**TITLE: QUINTESSENCE SUBDIVISION - UNIT 5  
GRADING AND EROSION CONTROL PLAN**

## GRADING AND DRAINAGE

### CERTIFICATION

#### QUINTESSENCE, UNIT 5

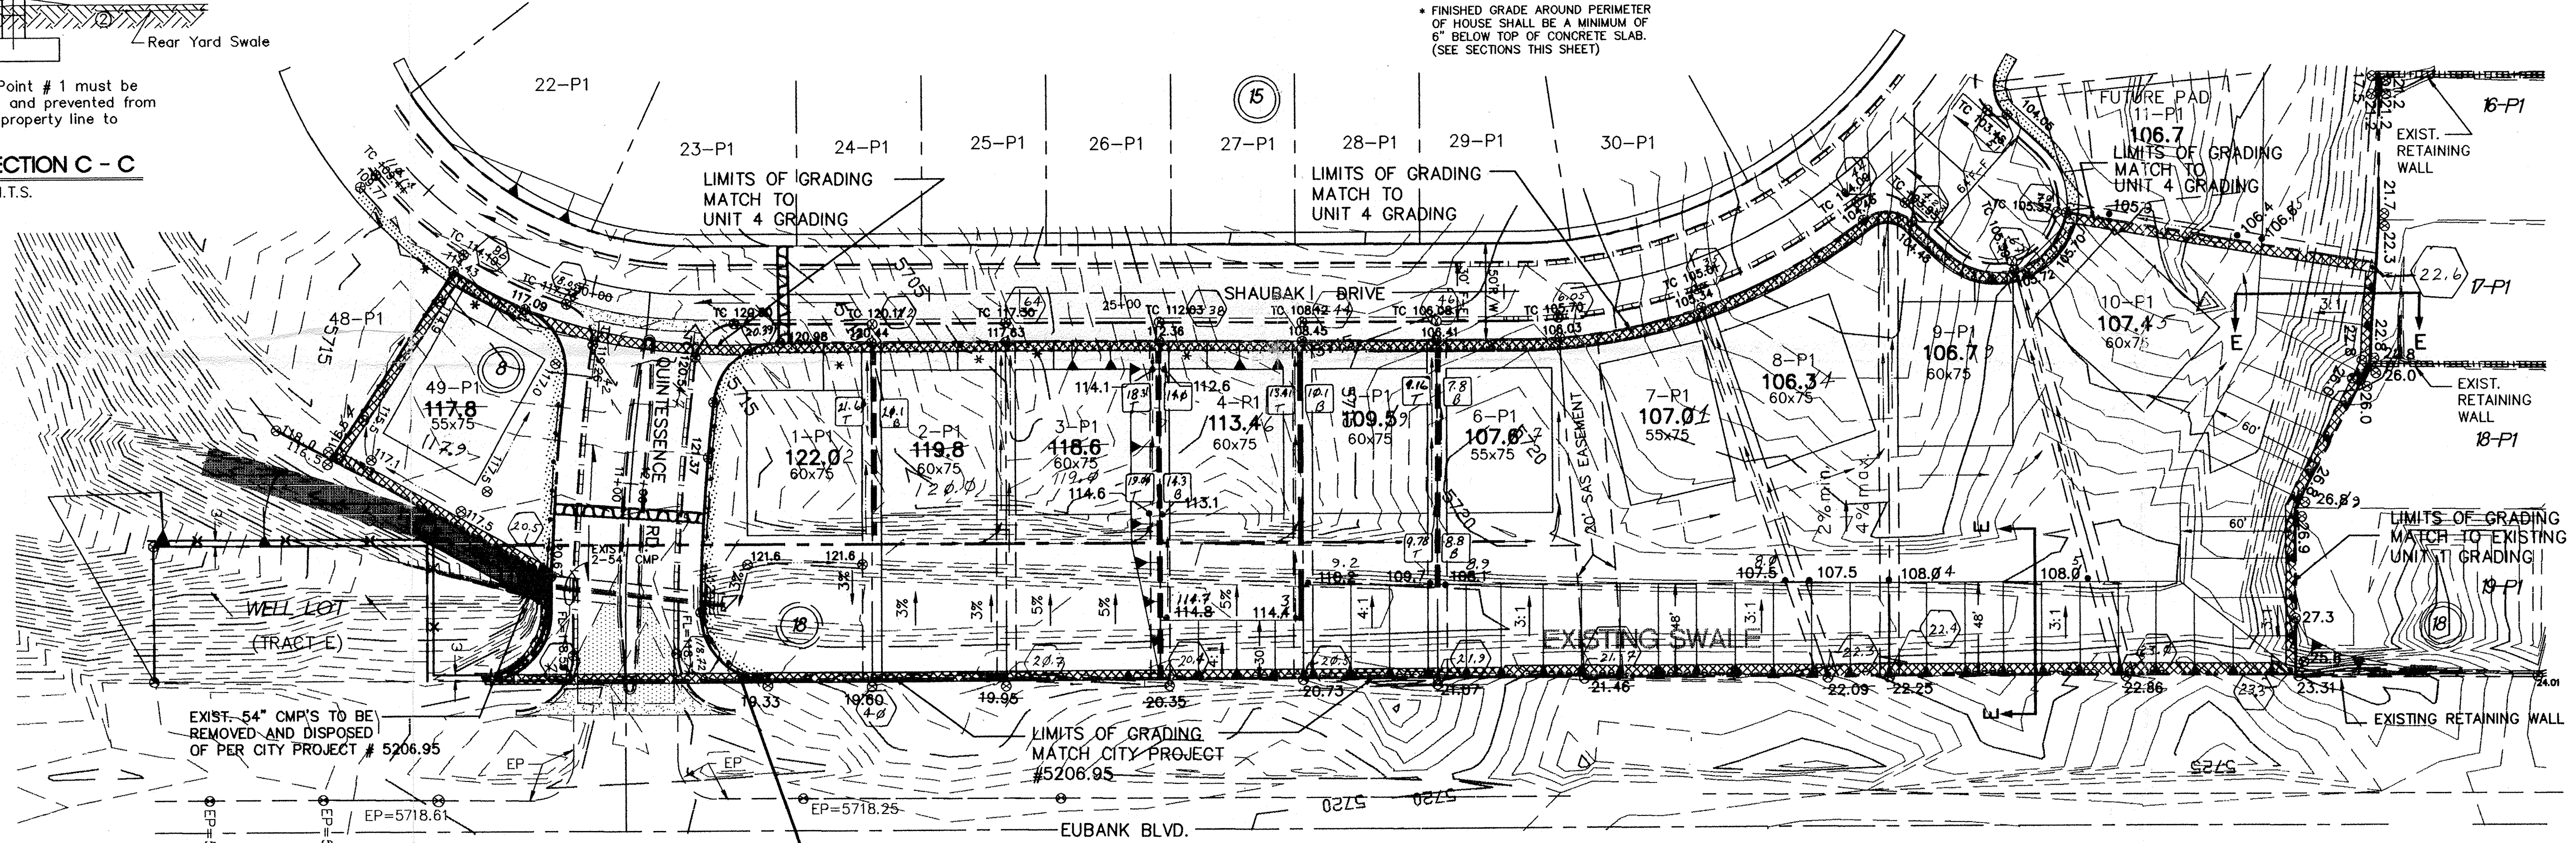
- a. The side yard slope of Lot No. 3 was eliminated and compensated by a higher retaining wall, the elevation difference between Lot No.'s 3 and 4 remaining as per design.

- a. Completion of the retaining wall extensions between the back of future (deferred) sidewalk and the front of the proposed houses is to be a responsibility of each house builder.

- b. Definition of side yard drainage swales will need to be fine graded for each lot upon completion of each house.
  - c. Provision for drainage openings in perimeter walls upon fine grading of each lot upon completion of house building is to be provided for by each house builder.

- d. Completion of side and rear yard walls that provide for both drainage control and minor (less than 18 inches) of soil retainage.
5. Each grading plan defined retaining wall, except as noted above, has been constructed in conformance with the parameters contained in the COA approved grading plan.
